**ITEM NO. 8201257 ET100M8-110 4/41PR ELECTRIC
POWERED VACUUM LIFTER W/ POWERED TILT
AND POWERED ROTATION - CUSTOM HANDLE**

SHEET 1 OF 2
Document No.: **82101123**
Revision: A
Effective Date: 05/16/2016

ACKNOWLEDGEMENT NOTICE

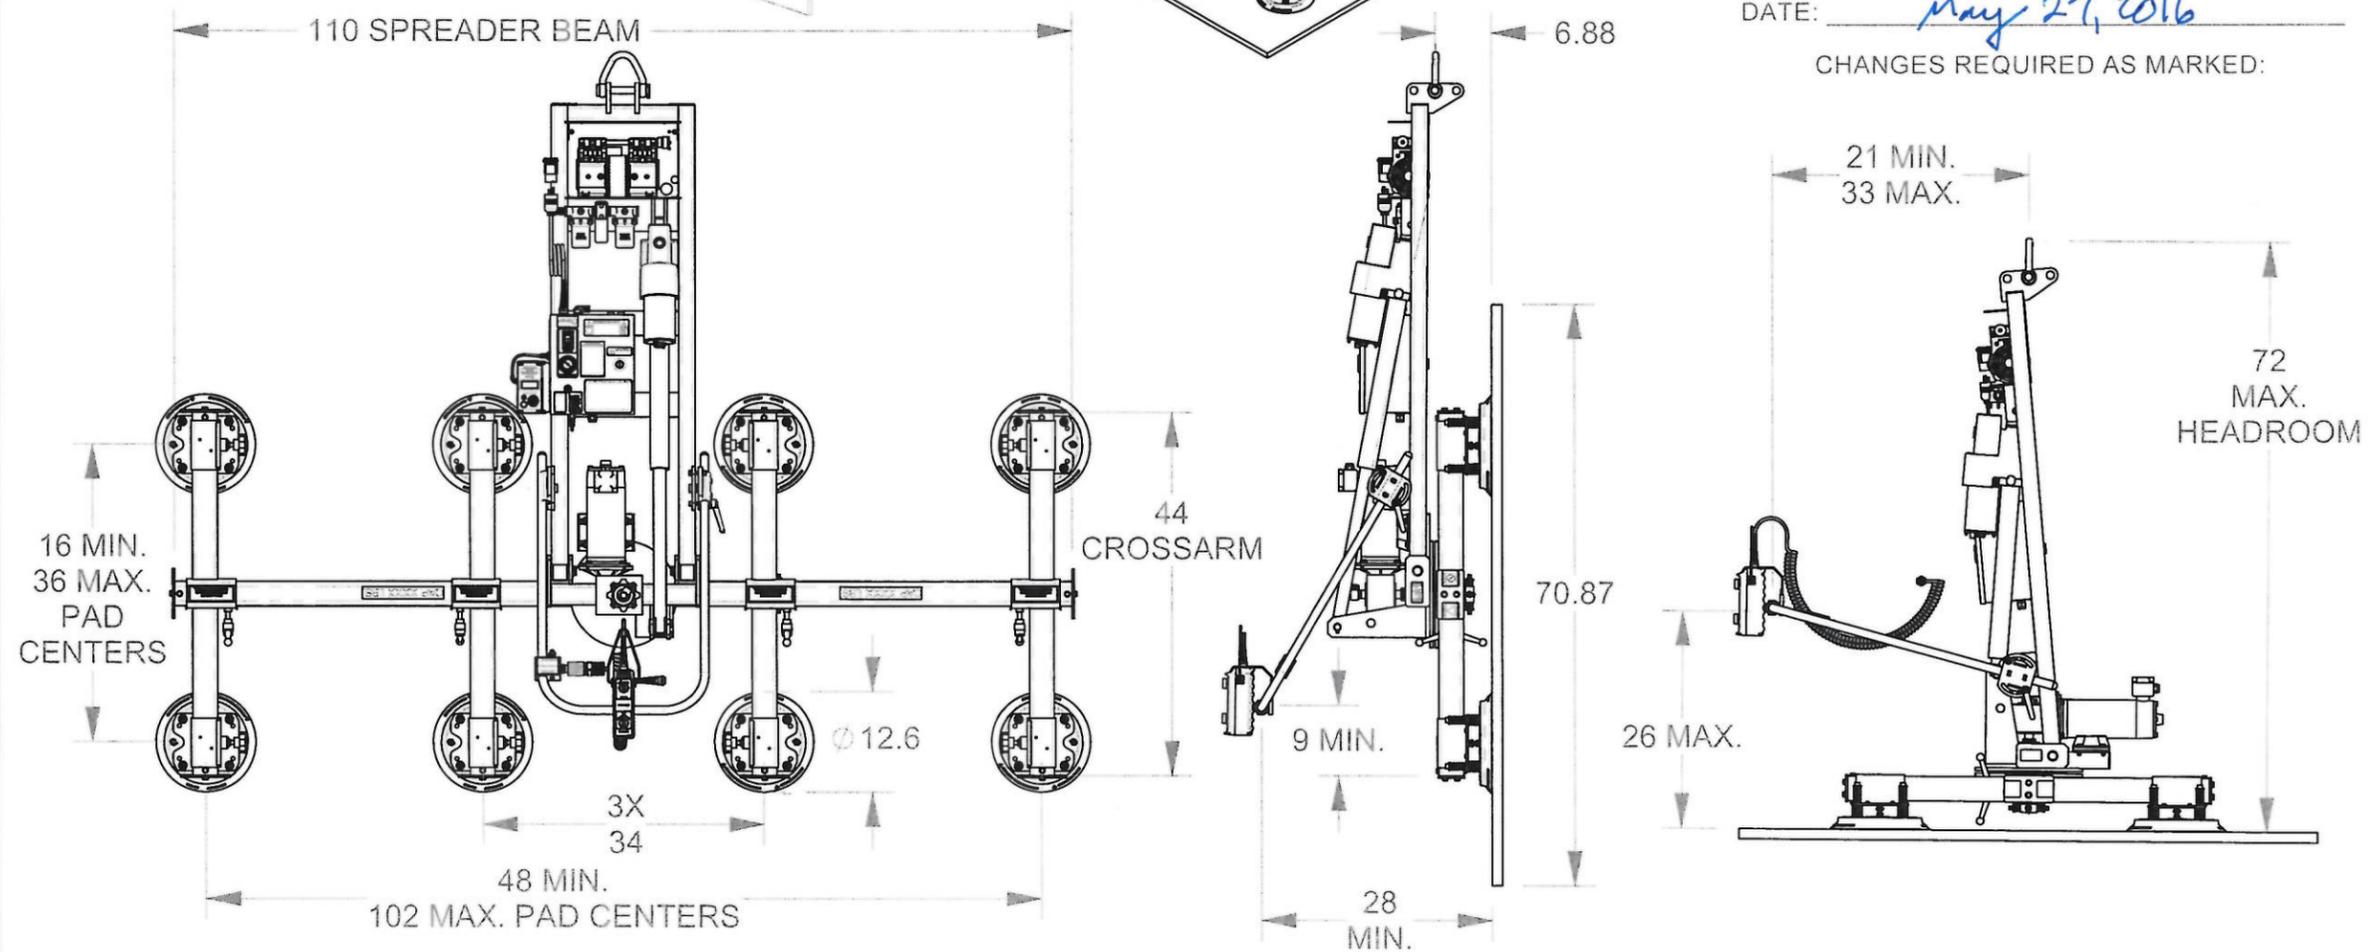
APPROVED BY: *as noted* [Signature] / A. Stefanik

CHANGES REQUIRED AS MARKED:
